Midland Manufacturing
7733 Gross Point Road
Skokie, Illinois 60077, USA
Tel: (847) 677-0333

TECHNICAL SERVICE BULLETIN (TSB) 20260303-01 Issued March 3, 2026

IOM Rupture Disc Holder Torque Value Superseded

Items Affected: Rupture Disc Holders assembled according to Installation, Operation, and Maintenance Manual, Doc. No. A-14378 Rev 1.4, paragraph 4.5.2.19 (hereafter "IOM").

Figure 20 - Rupture Disc and Disc Flange

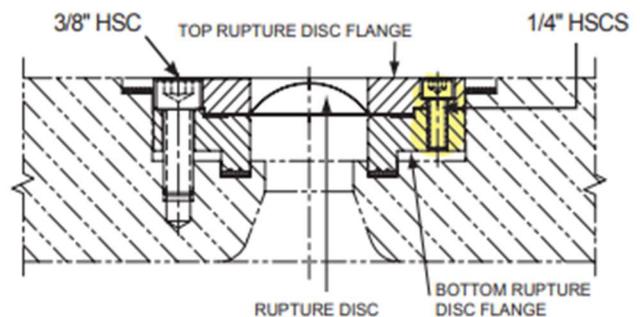
- Torque of rupture disc holder cap screws (highlighted in Figure 20, below) is **currently** specified in the IOM excerpt shown here:

4.5.2.19 Close the needle valve or reinstall the plug or indicator. Place the disc on the bottom flange and then place the top flange on top of the rupture disc holder assembly. Tighten the 1/4" HSCS in 1/3" torque increments in a diagonally alternating sequence to a torque of **13ft-lbs** for the monel material bolts and for other materials please consult Midland. After rupture disc holder assembly is assembled together, install rupture disc holder per 4.5.2.11.

- 13 ft-lbs applies excessive force to monel material screws, risking yield of the material.

- Until next IOM revision is published, tank car facilities must apply **7 ft-lbs** torque to highlighted cap screws.
- Do **not** apply lubricant to cap screws or cap screw holes.
- All other provisions of the IOM remain in effect as-written.
